X3T9.2/92-49

SCSI-3 CONNECTOR

WORKING MEETING

Working Meeting 3/16/92

ATTRIBUTES TO THE RECEPTACLE PORTION

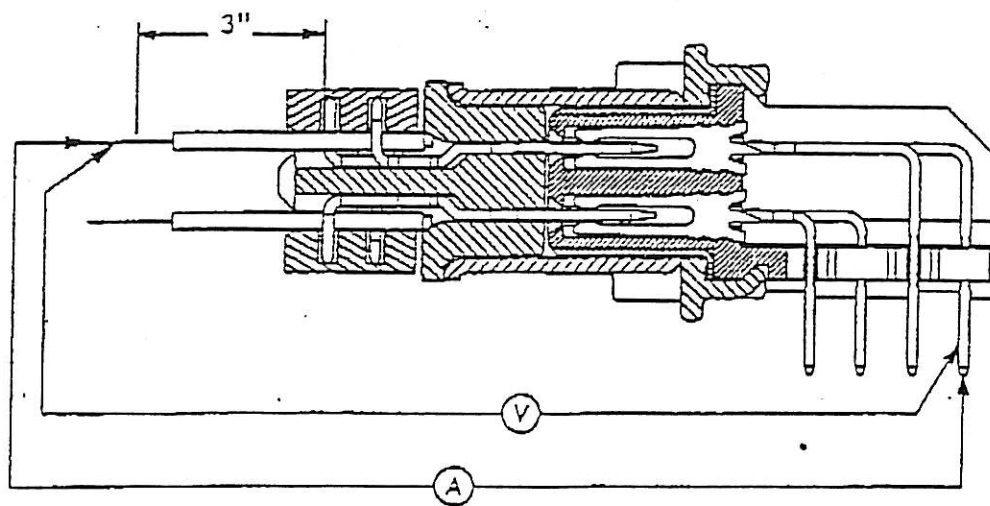
- CHANGE NOTE TO READ --THE SOCKET CONTACTS TO BE CENTERED IN HOUSING
